September 19, 1993  
Project 218

RE: Snow Cleaners, 2687 Coolidge Ave., Oakland, CA: RESPONSE TO  
AUGUST 17 LETTER AND PROJECT SCHEDULE UPDATE

# MONITORING WELL CONSTRUCTION DETAILS

SNOW CLEANERS  
OAKLAND, CALIFORNIA

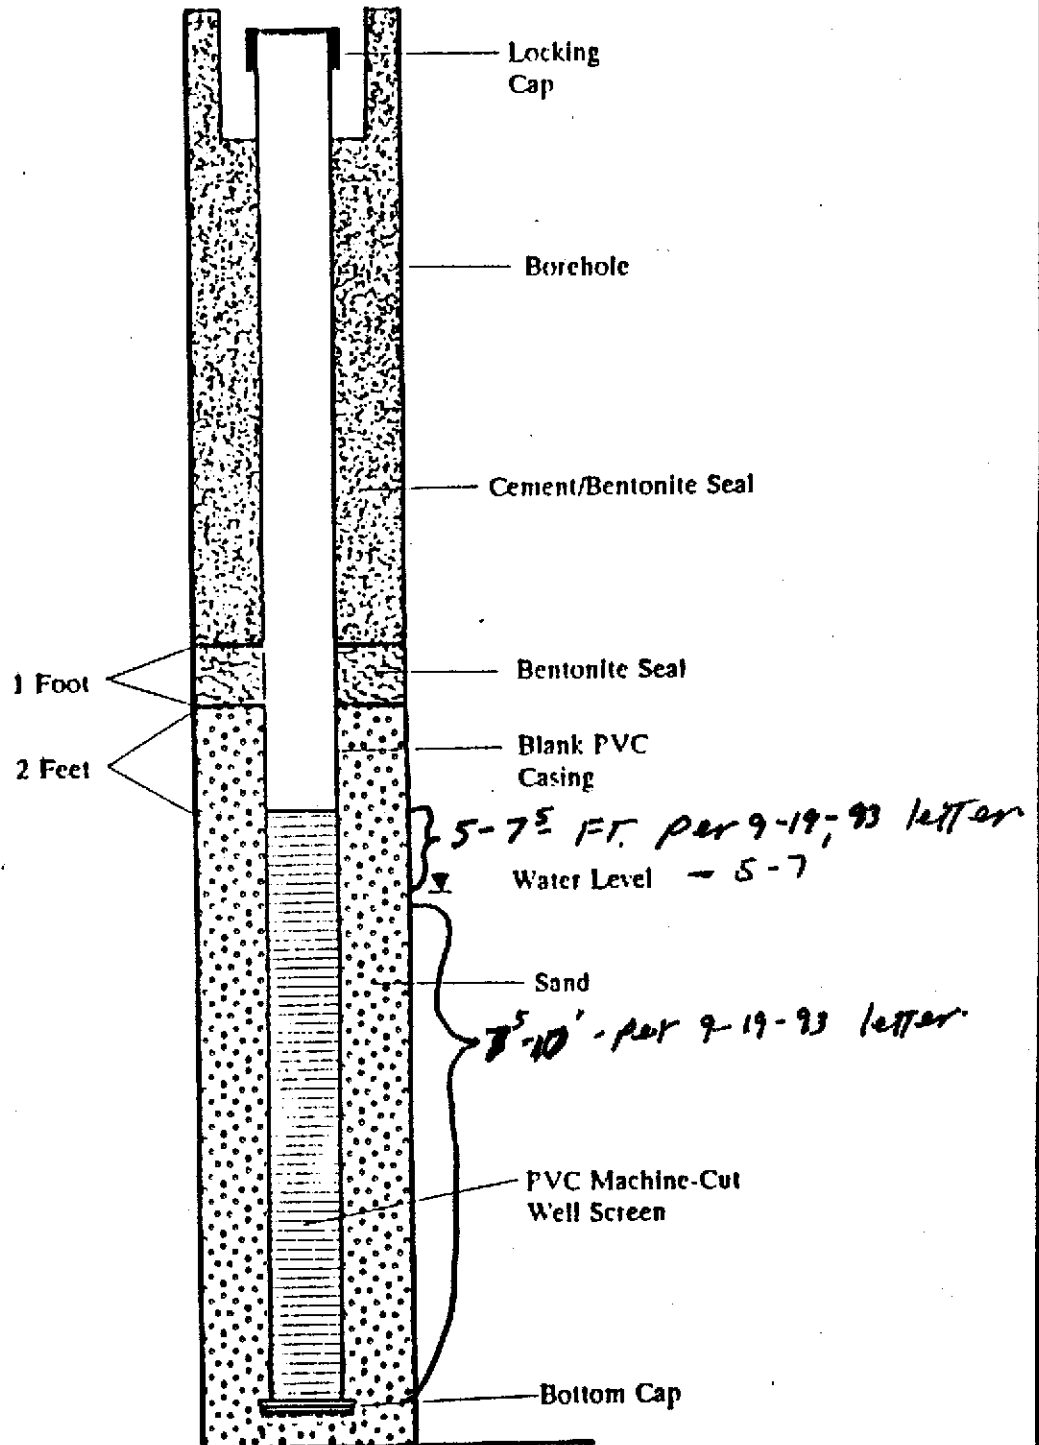
We apologize for leaving out the typical well construction plan from our July 30 letter to you. It has been included with letter. We concur in general with your encouragement of 15 feet of screening of wells in the vicinity of the "water table". Our general policy is to screen at least five feet above the water level at time of drilling, and for at least five feet, and preferably approaching 10 feet, below the water table. We presently understand that you have informed Mr. Chris Pruner of Kvilhaug Drilling - our drilling contractor for this project - that you estimate water levels in the 60 ± foot depth range at the subject site. It has been our general experience - mostly with inland sites - that the water table dropped some during the recent six years of drought, and that the last year of more-than-average rainfall did not substantially impact the ground water table to yet recover lost depth. Therefore, we have been more inclined to screen higher above the water table, and less deep into it - splitting the table about halfway with our screened sections instead of 34-66 %. In your experience, has a corresponding drop in water table elevation occurred in the general area of Oakland that Snow Cleaners occupies. If it has, we would suggest considering screening approximately both 7.5 feet above and below the present water table. We will clarify this with you either verbally or in writing prior to drilling, and will screen the wells in whichever manner you deem most appropriate. We will use 15 feet of screening in each well, it is just a matter of determining the distribution.
